## INVITATION FOR BIDS

CCK-2844.00-1-25

Princeton Greenhouse - Headhouse

ADDENDUM #1

**C NORTH BUILDING ELEVATION - BASE BID**  
1/4" = 1'-0"

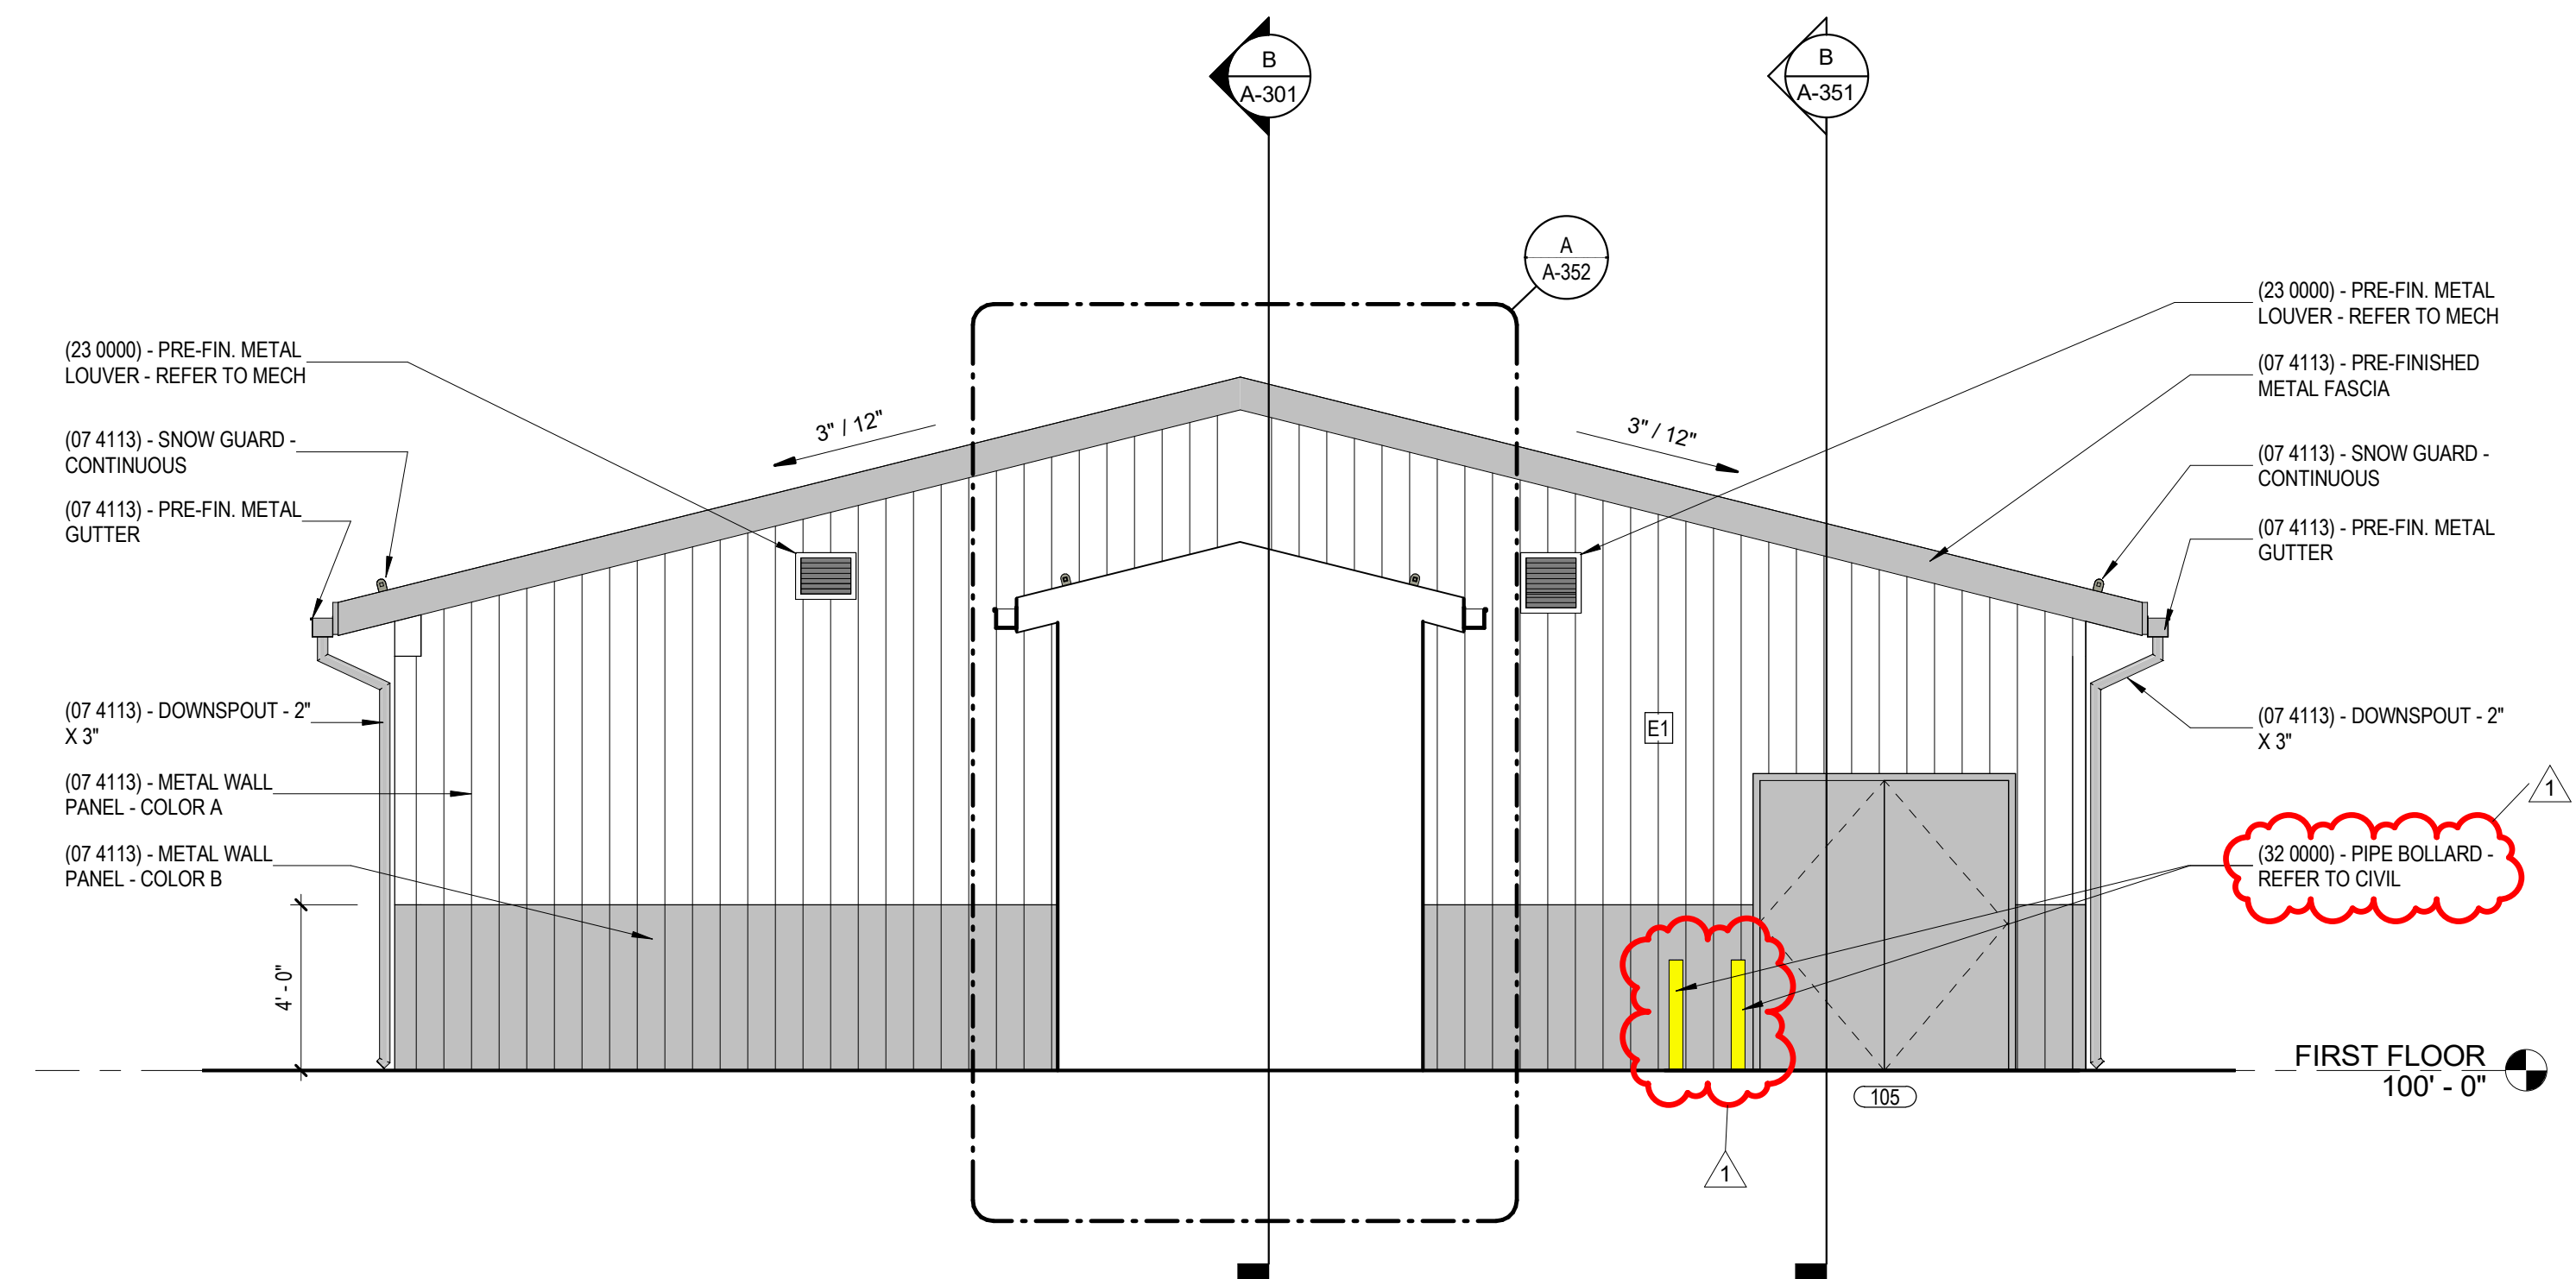
Refer to attached sheet A-101, A-102, A-201, A-202. Added bollards around HVAC unit, generator, and gas meter. Refer to civil & electrical for additional information.

G-102

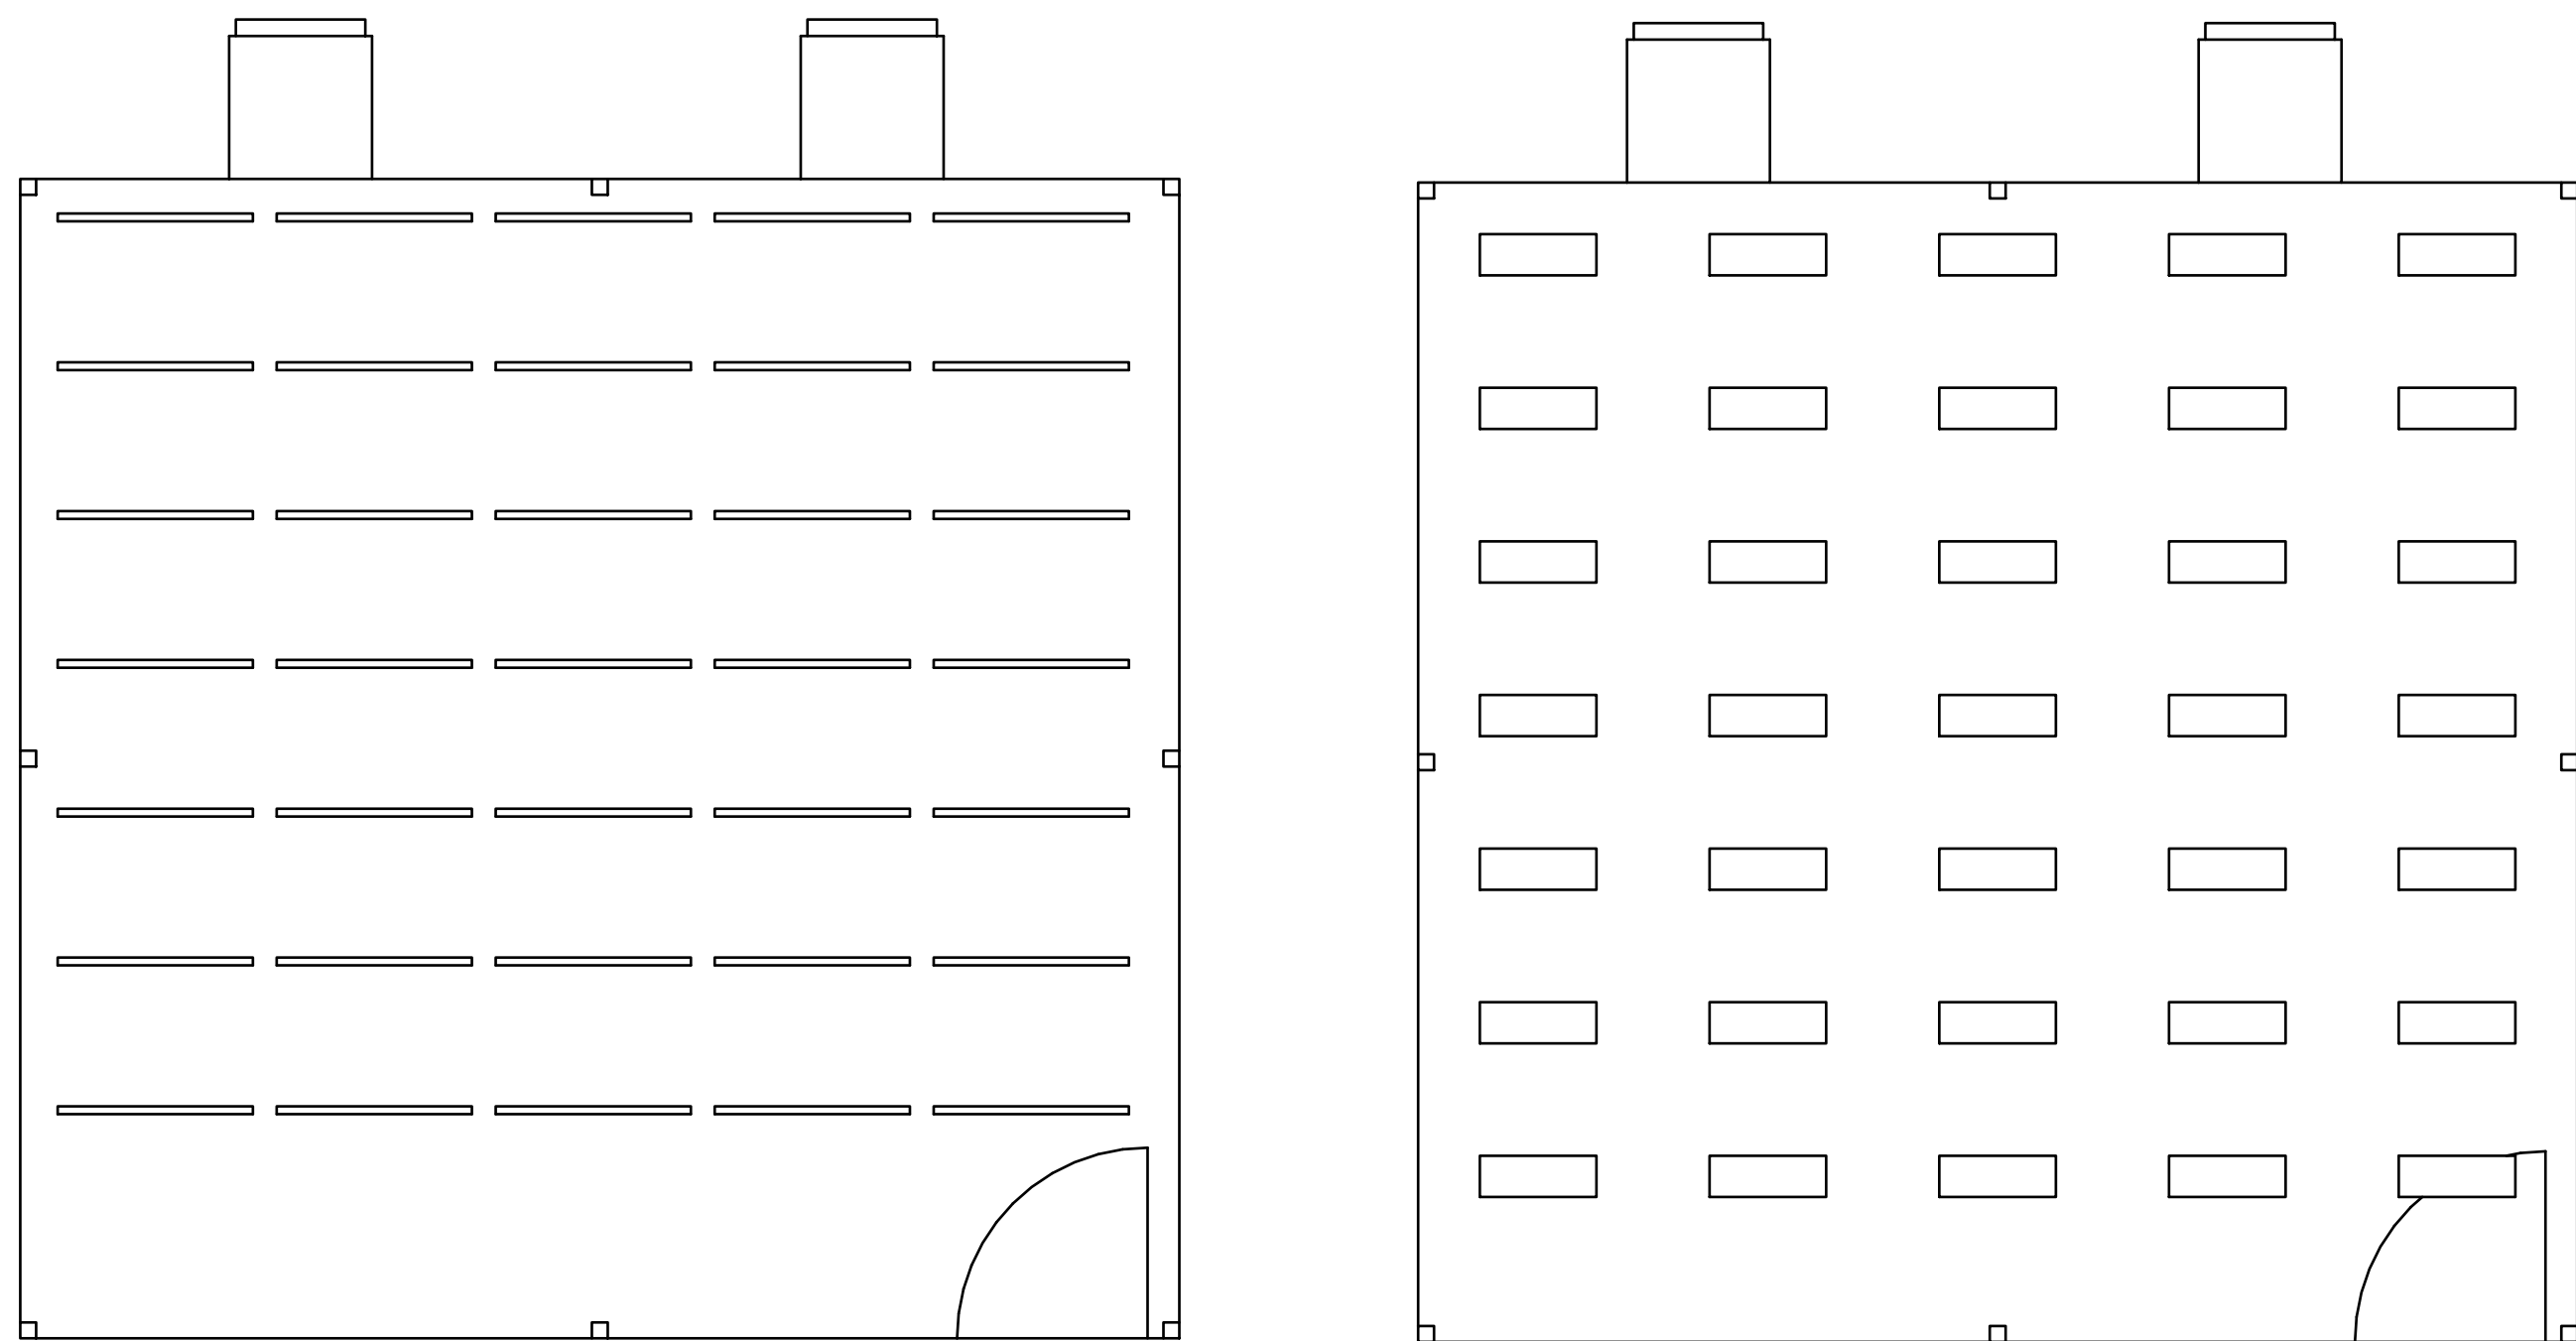
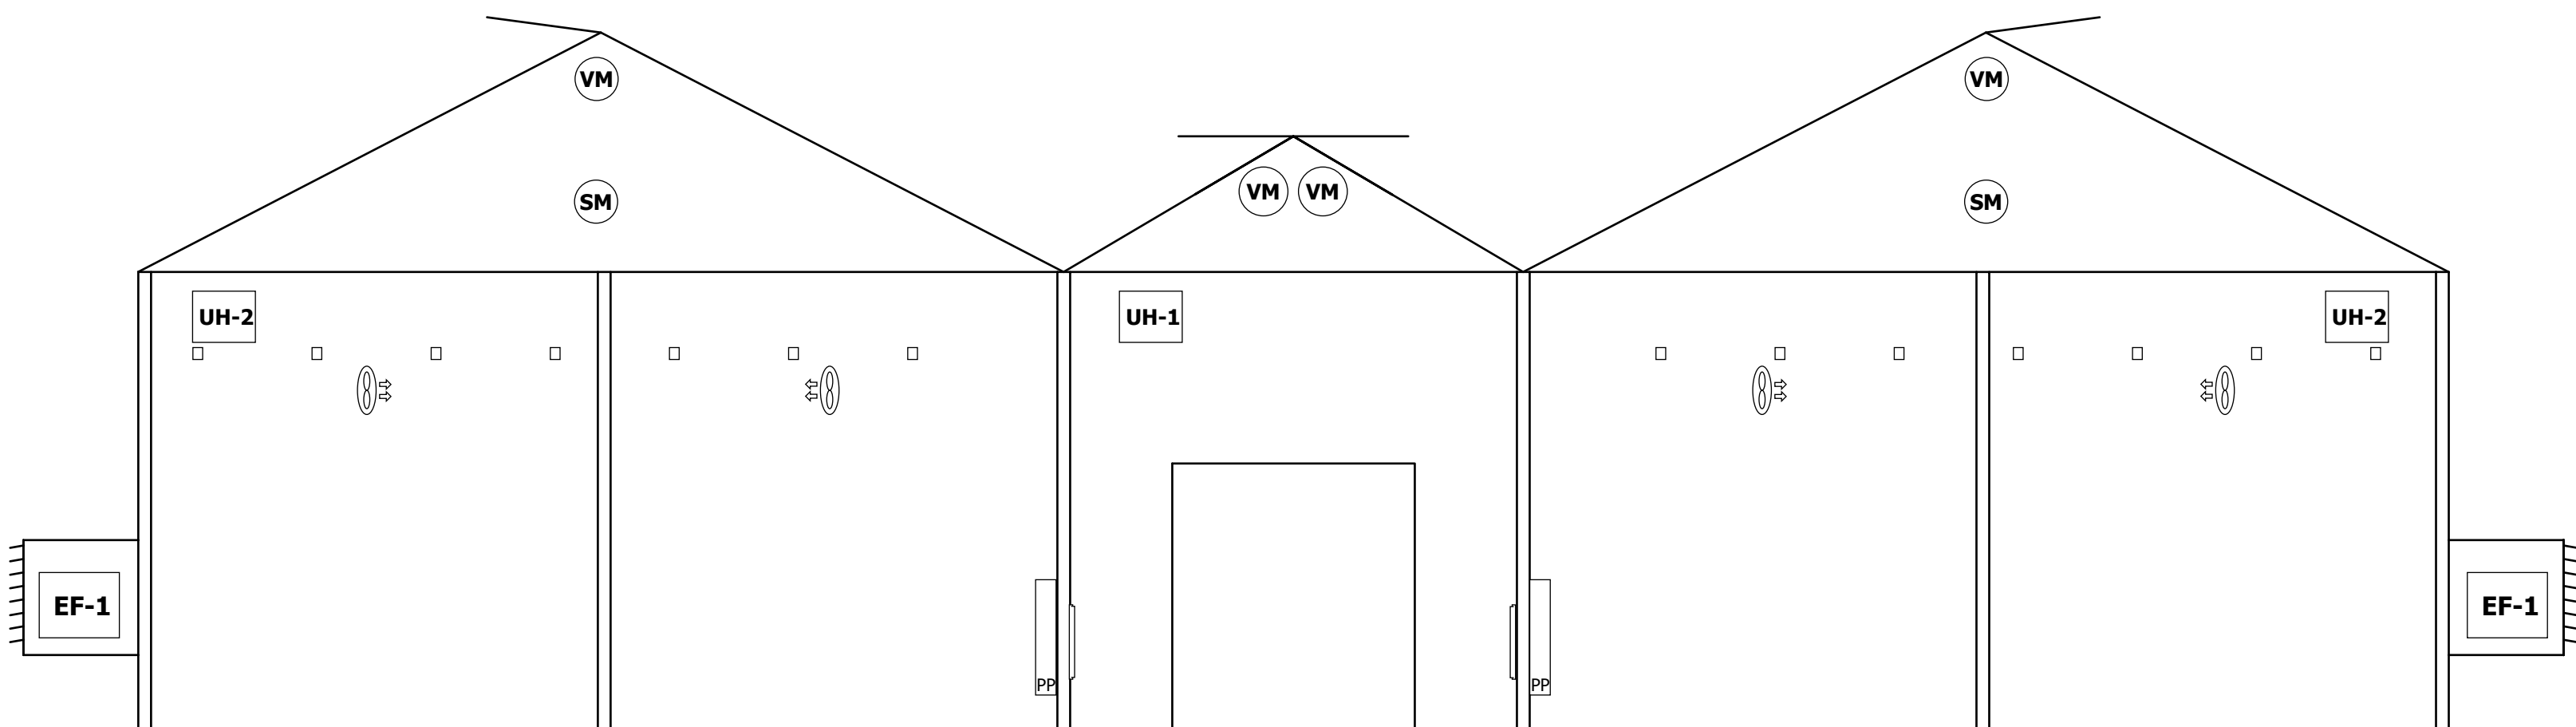
18	4/3/2025	On lighting in specs it calls for Phillips model 1830 which is available in 208v, drawings call for alternate to be model 1925. This is not available in 208v.	LLK Greenhouse Solutions	Use 1830 TLC DRW_EBW for high light alternate bid, drawing has been corrected
19	4/3/2025	On the lighting do lights need to have 0-10v dimmable capability? 200 micromoles doesn't necessarily need dimming capability according to manufacturer. The 600 micromoles is very high intensity. The manufacturer recommends dimming on this fixture. The 600 micromole option is 3 times the 200 micromole option as a general guideline. The 600 micromole option isn't available as a daisy chain. Would require hardwire to lighting panel individually.	LLK Greenhouse Solutions	Alternate lighting bid requires dimming. This is accomplished with 0-10v dimming adapter for the 1830 TLC in conjunction with the Seed Control System, one dimming zone per compartment. Supplemental product materials attached and corrected drawing calls out 0-10v dimming requirement. Please refer to the TLC Application guide for direction on daisy chain options for the TLC1830 fixture. There are charts in the application guide that show how many fixtures can be daisy chained together.
